ADDENDUM NO. 2

RE: ADDENDUM NO. 2 PARK AVENUE SIDEWALKS IMPROVEMENT PROJECT BIDS DUE JUNE 19, 2019 AT 3:00 P.M.

City of Capitola, California

Revised/Additional Plan Sheets Provided: L-5, L-6, CD-3, CD-7, DR-2, RW-1, SS-5, SS-6

Addendum 2 - Bid Items 14 & 43 Updated Plan Sheets

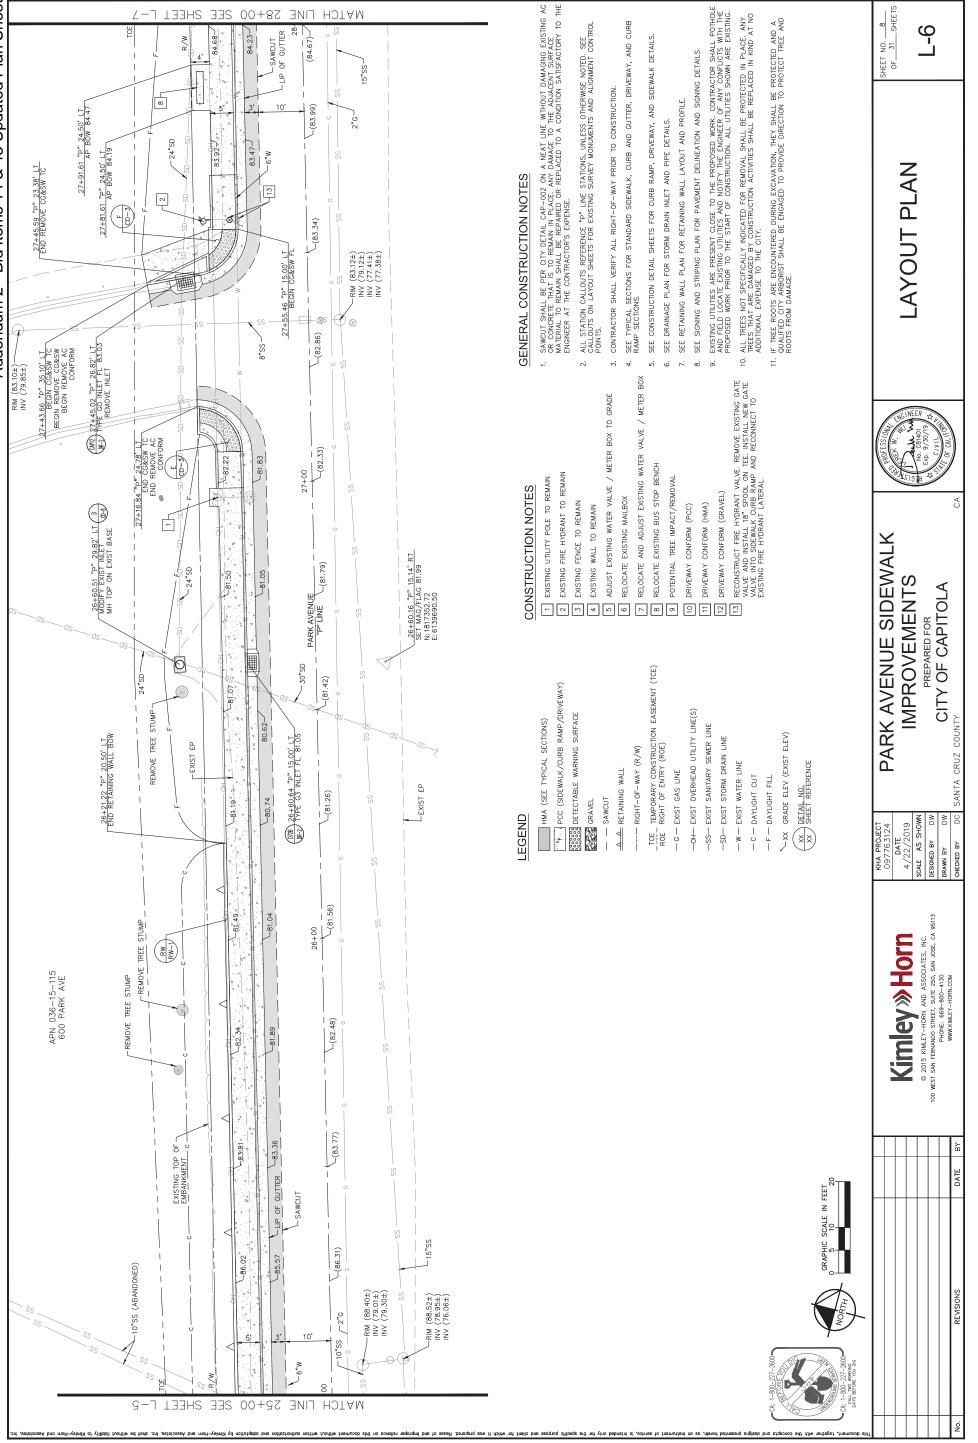
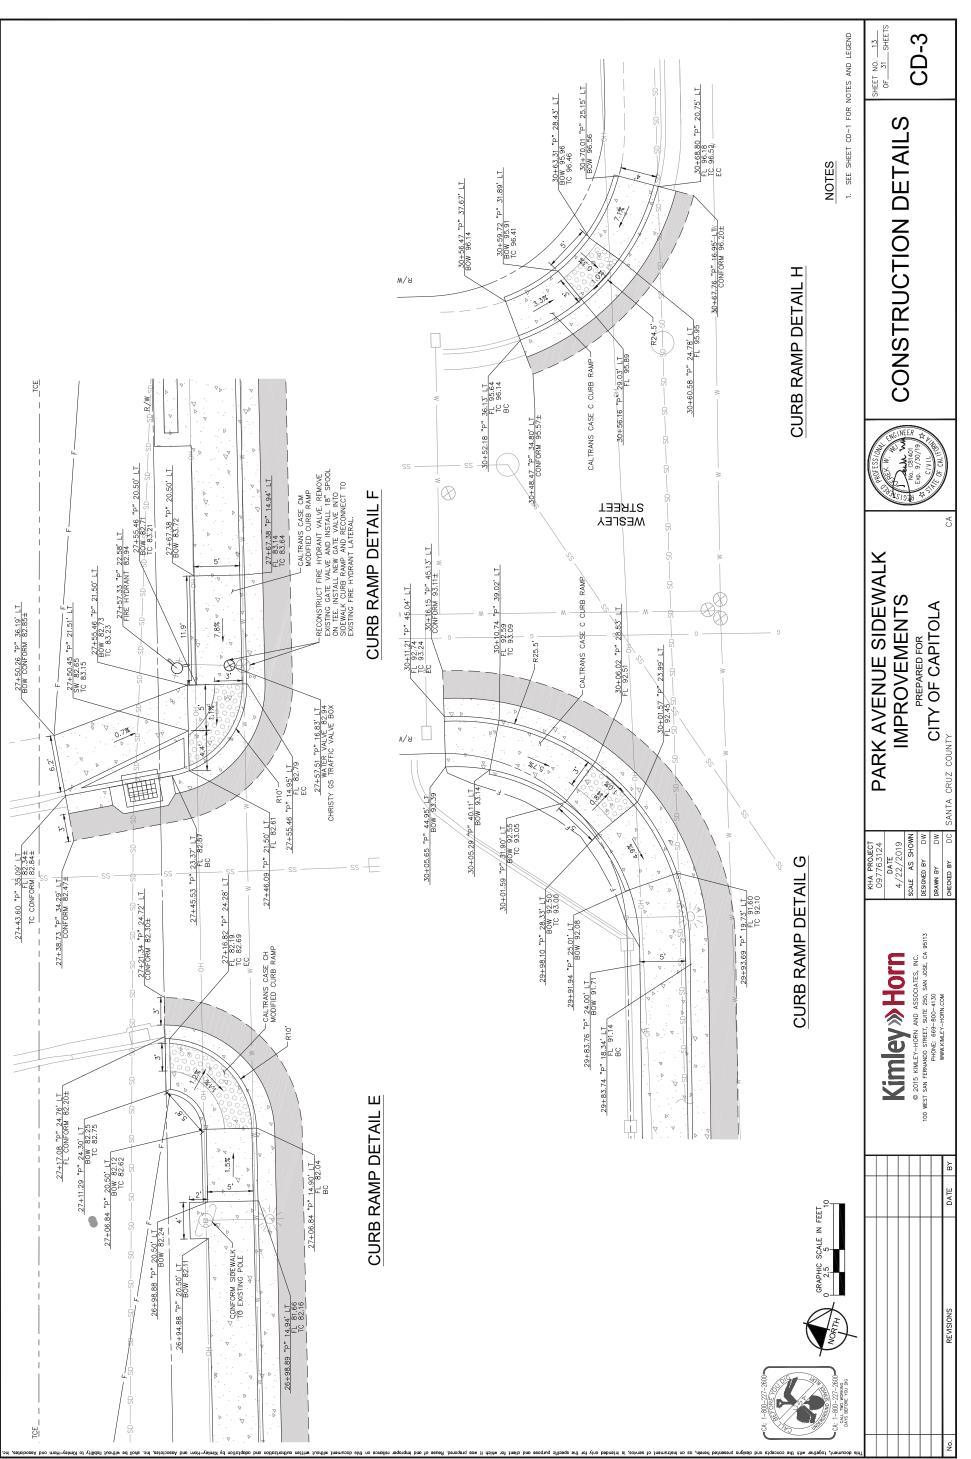
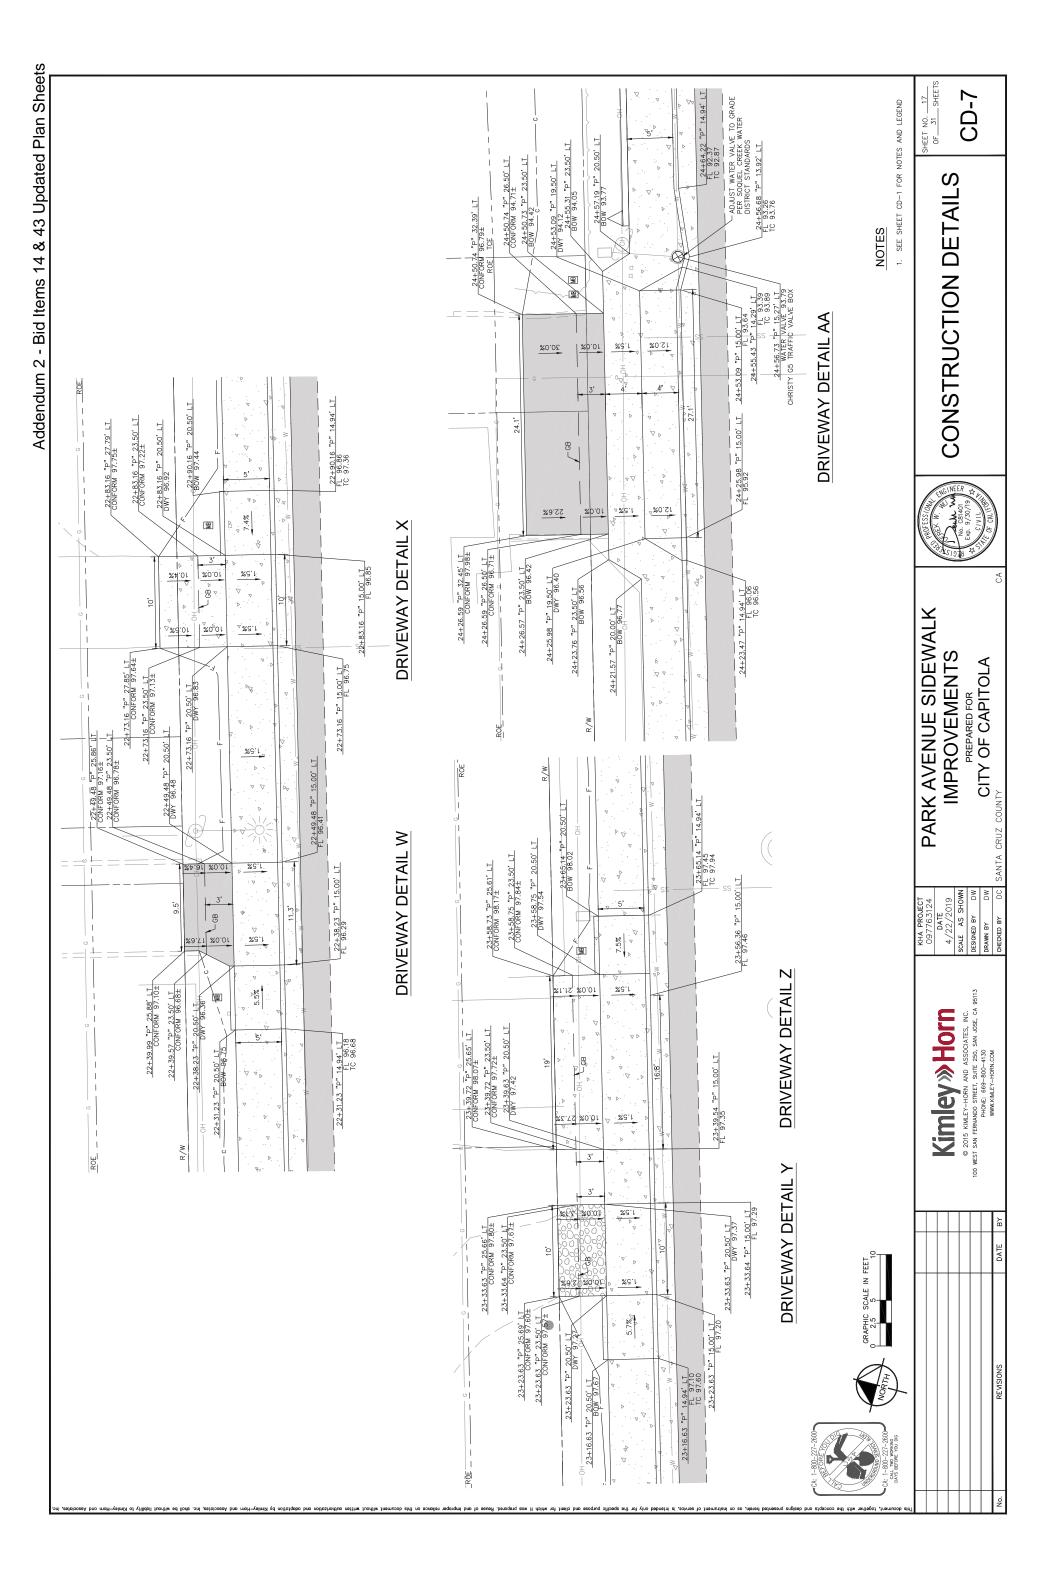
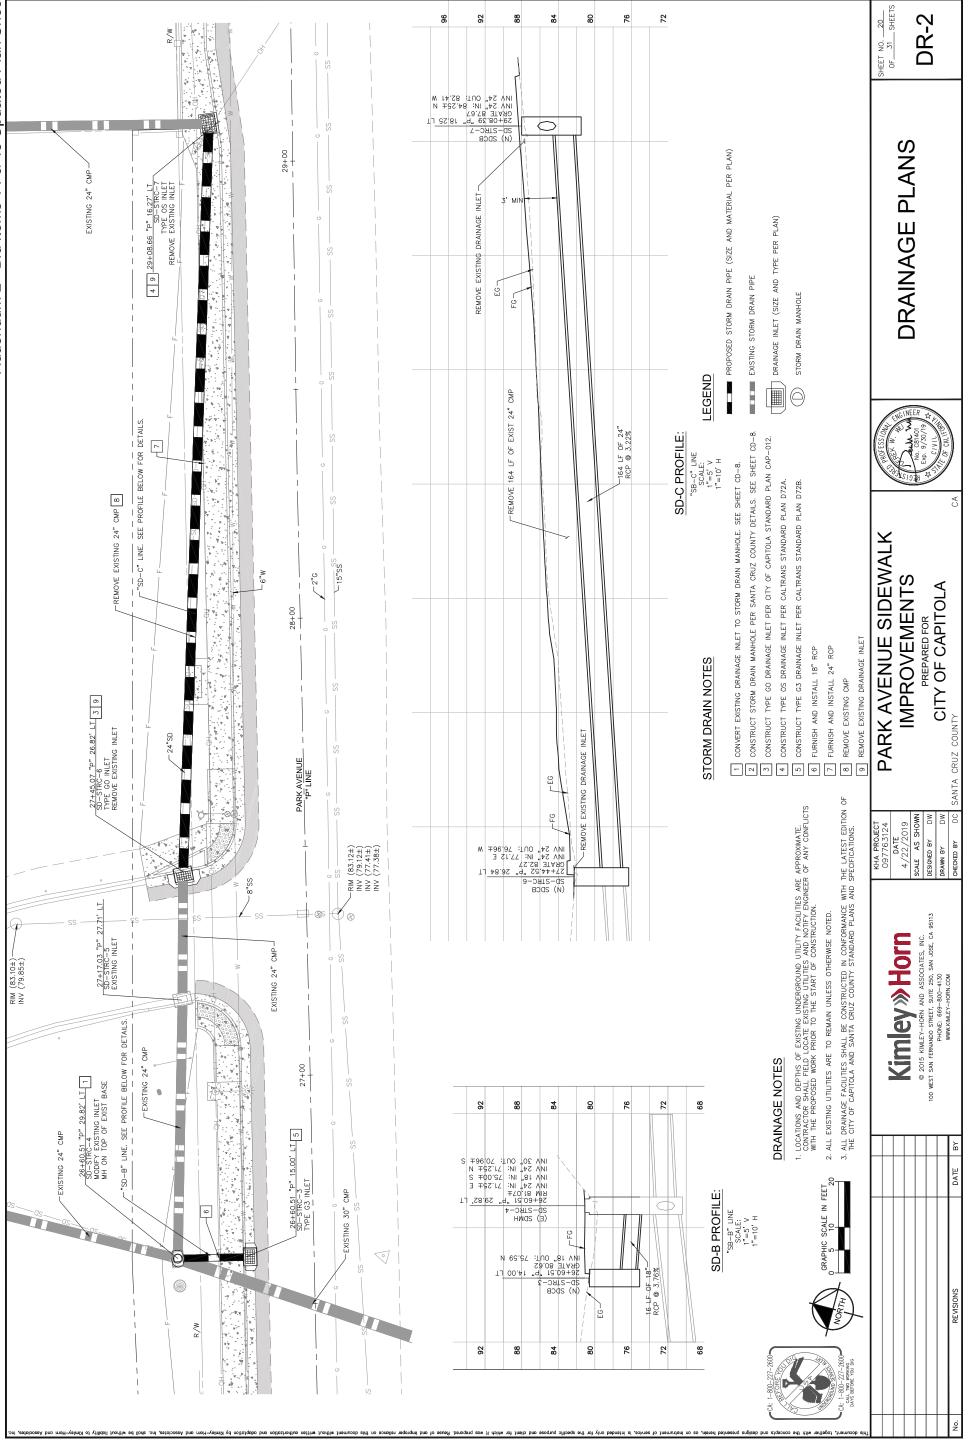
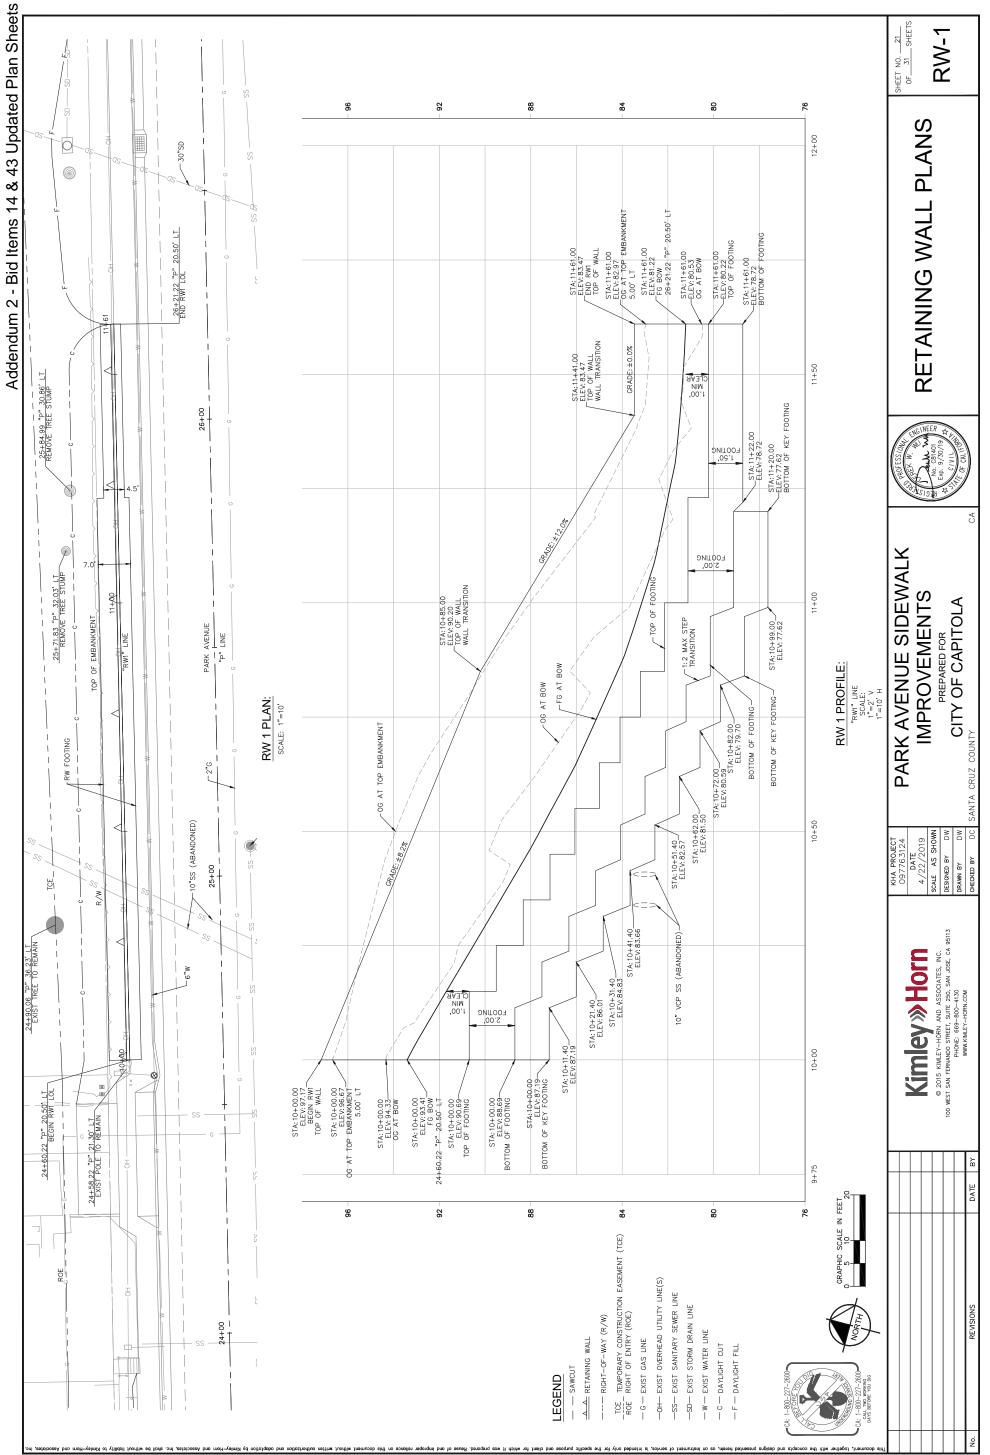
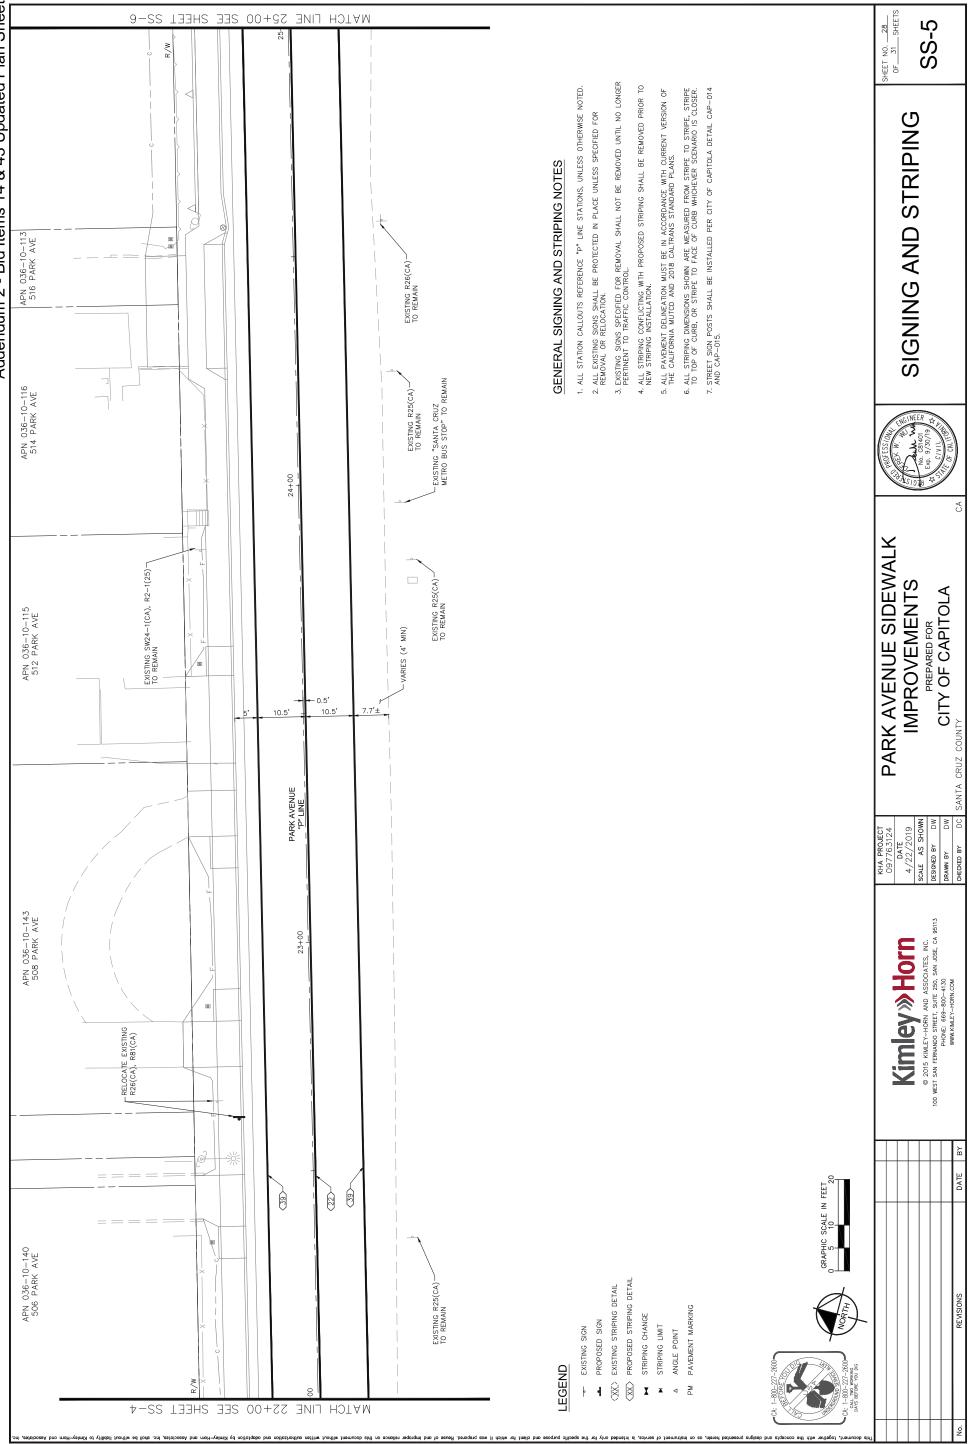
- 1. Sheet L-5 Relocate Valve.
 - a. See updated Sheets L-5, CD-7, RW-1 and SS-5 (Addendum 2 Bid Items 14 & 43 Updated Plan Sheets) The existing water valve on Sheet L-5 will remain and be adjusted to grade in the proposed sidewalk per the revised plans.
- 2. Sheet L-6 Relocate Valve.
 - a. See updated Sheets L-6, CD-3, DR-2, and SS-6 (Addendum 2 Bid Items 14 & 43 Updated Plan Sheets). This work will be a separate bid item titled "Reconstruct Fire Hydrant Valve". Remove existing gate valve and install 18" spool on tee. Install new gate valve into sidewalk curb ramp and reconnect to existing fire hydrant. The existing fire hydrant on Sheet L-6 will need installation of a new spool, gate valve, and lateral connection.
- 3. Revised Bid Sheet Provided New Bid Item 43 "Reconstruct Fire Hydrant Valve"
